STAFF REPORT
COMMUNITY DEVELOPMENT DEPARTMENT

SUBJECT: PP - H-2022-0006
 Jump Creek South Preliminary Plat

Request for a preliminary plat consisting of 20 single-family residential lots and 4 common lots on 3.57 acres of land in the R-8 zoning district, by Kent Brown.

B. "Proposed" Jump Creek South Preliminary Plat (date: 9/24/2021)

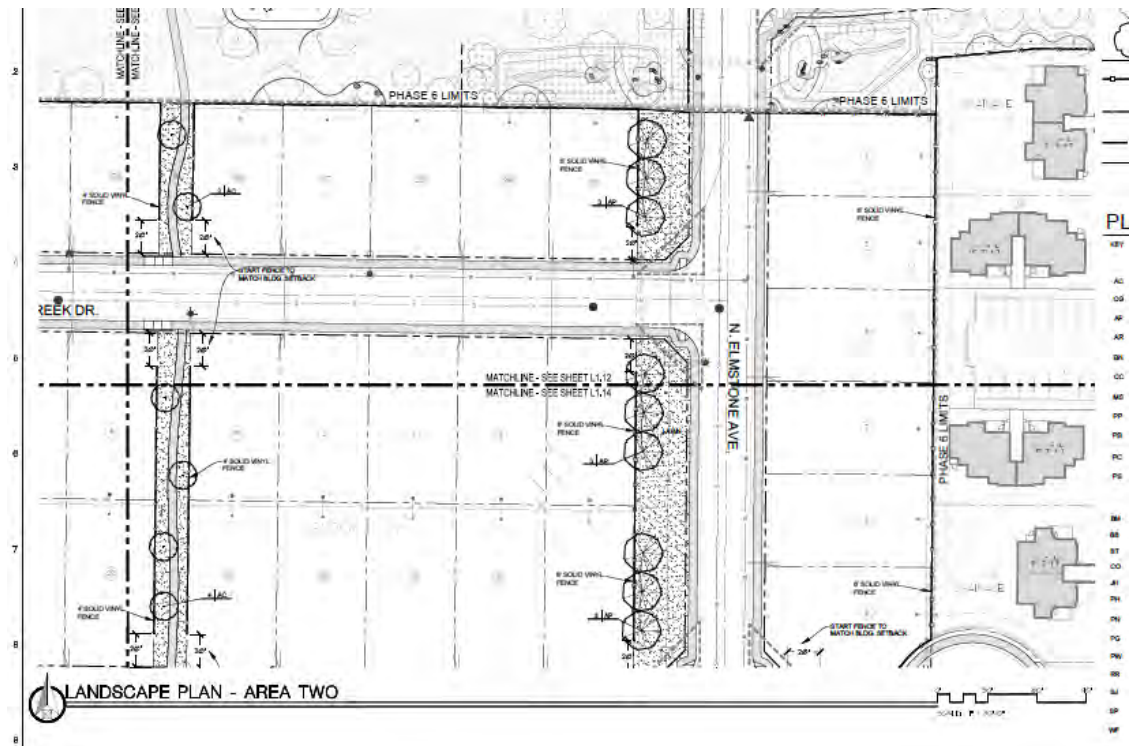
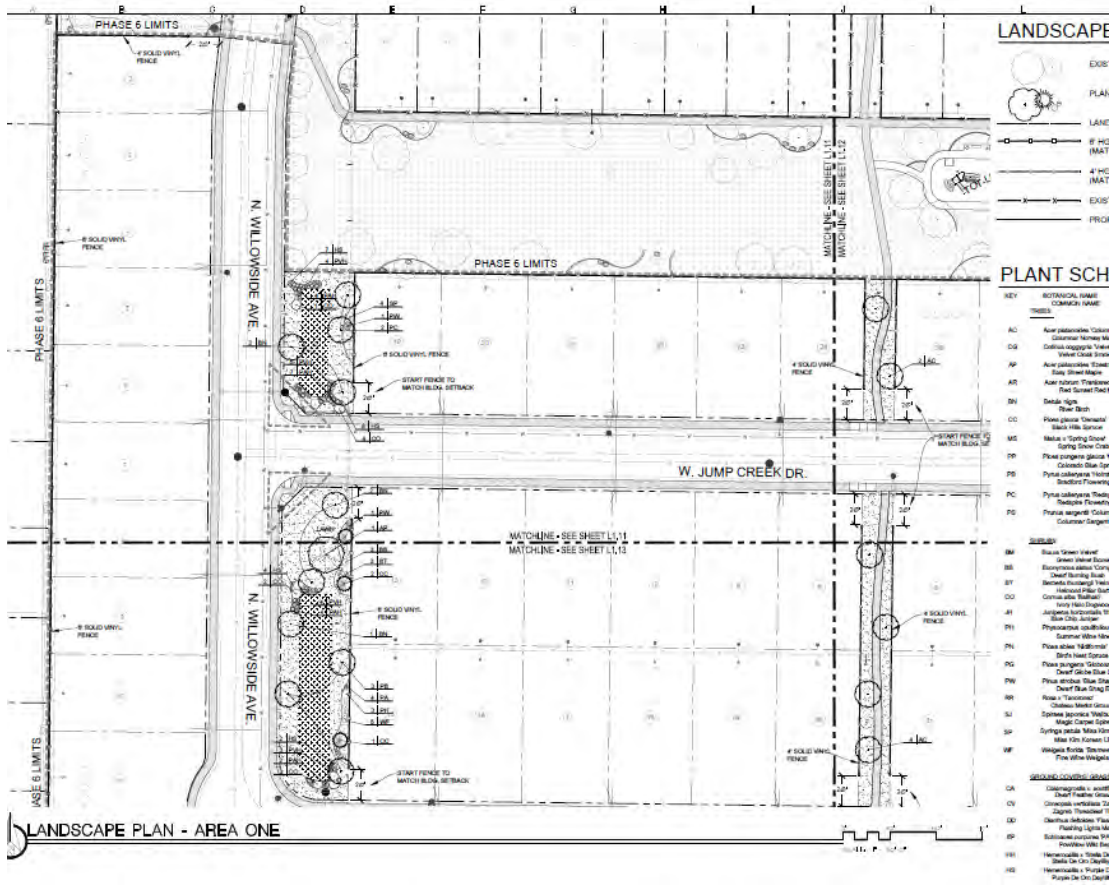
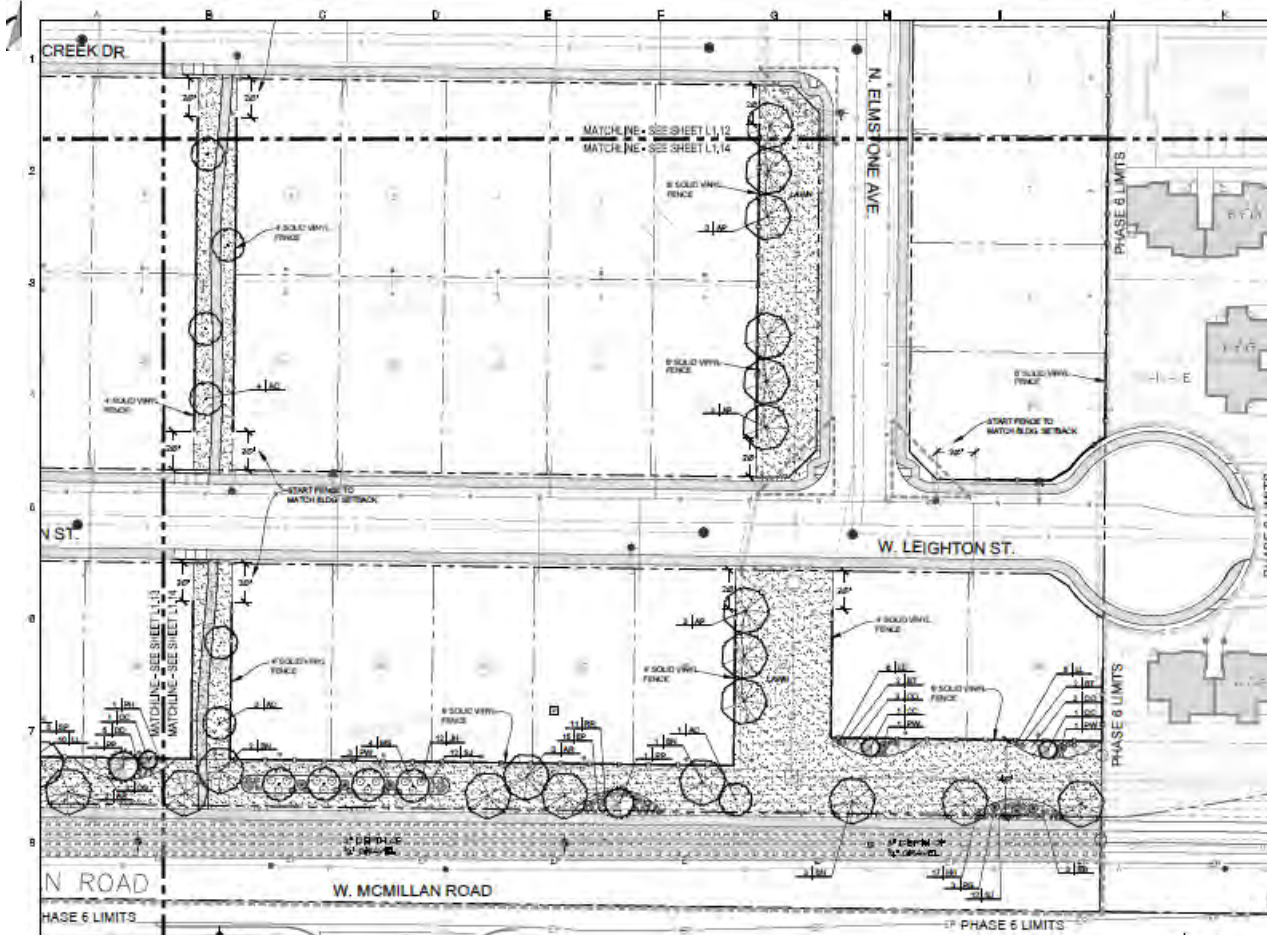
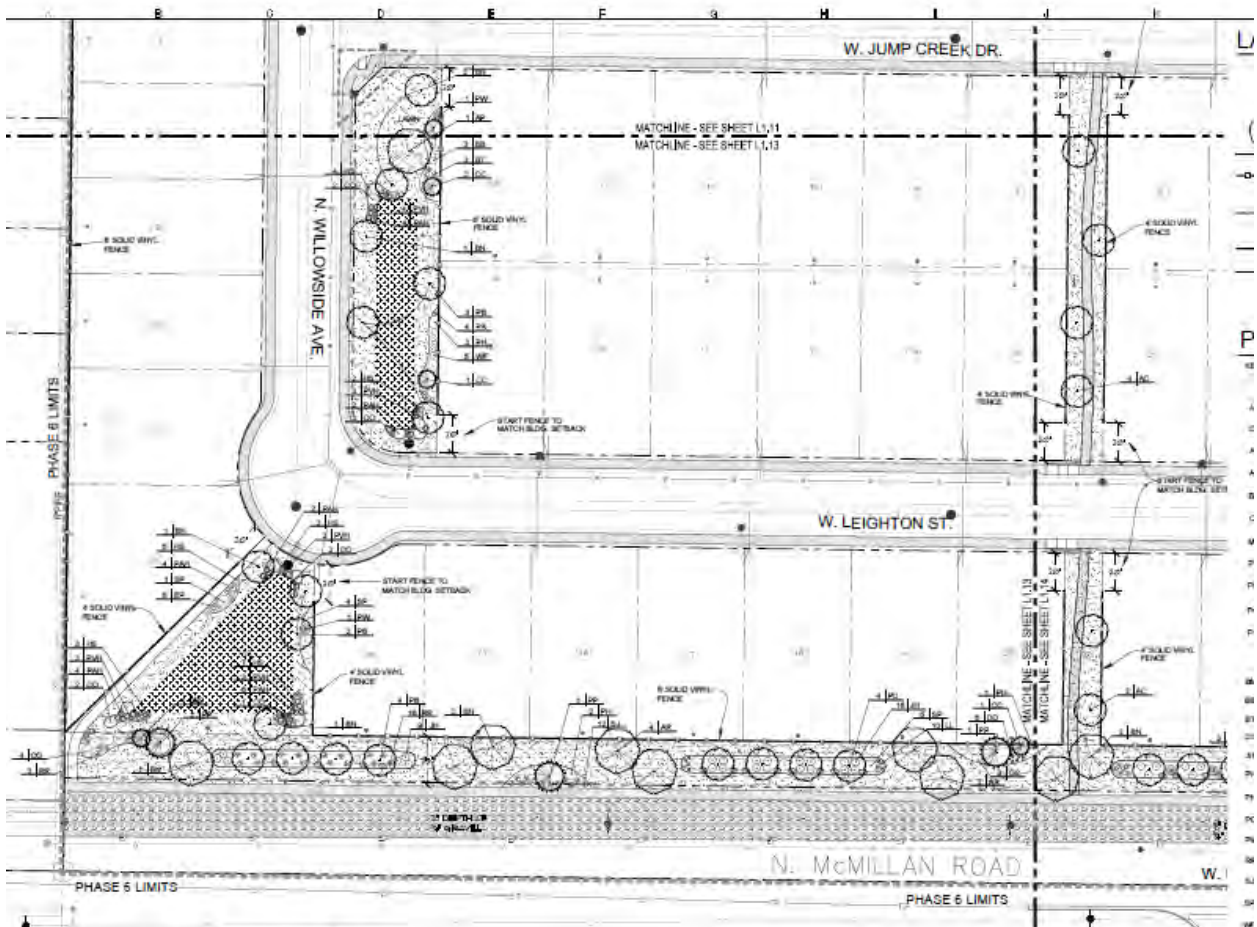
1. The Preliminary Plat included in Section VI, is approved with the following revisions:
 - a. Add date to the plat.
 - b. Revise Preliminary Plat name to read “Jump Creek South Subdivision.

The landscape plan does not indicate whether there are healthy existing trees meeting the preservation requirements on the property. With the submittal of the final plat the applicant should submit a revised landscape plan that details any mitigation plan outlined by the developer and the City Arborist.

2. The Landscape Plan included in Section VI, dated 11/2/2020, is approved with the addition that the landscape plan shall indicate whether there are healthy existing trees meeting the preservation requirements on the property.
